MEMORANDUM

SUBJECT: BZA Application 18157: 2221 14th St. NW

Proposed Parking Level Plan

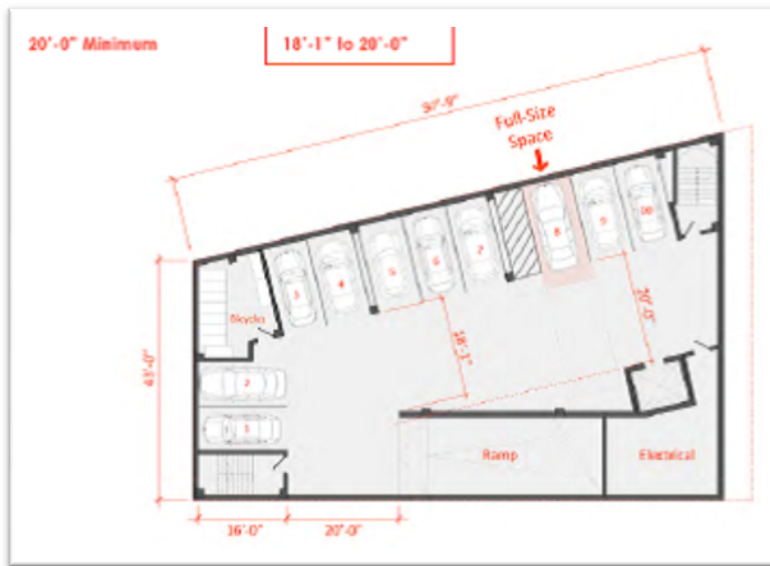
The lot's exceptional situation regarding its area and shape create a practical difficulty to provide the required drive aisle width throughout the entire garage, exclusive of columns, as stated in the provision. In this instance, one support column directly affects the required measurement in a small area, as shown in the diagram below. Since this support column is integral to the design, the drive aisle is effectively reduced from 20 feet to 18 feet in this location only. The narrow width of the lot in this area creates a practical difficulty in providing the required distance between the two columns shown in the diagram below.

Granting this variance would not impair the intent, purpose and integrity of the zone plan, as only one parking space would be impacted, requiring additional turns for accessing and maneuvering to that space. This does not affect the intent of the Zone Plan, since the drive aisle width would not be reduced throughout the garage. Therefore, the intent and purpose of the provision would not be impaired and it would have no adverse impact on the Zone Plan.
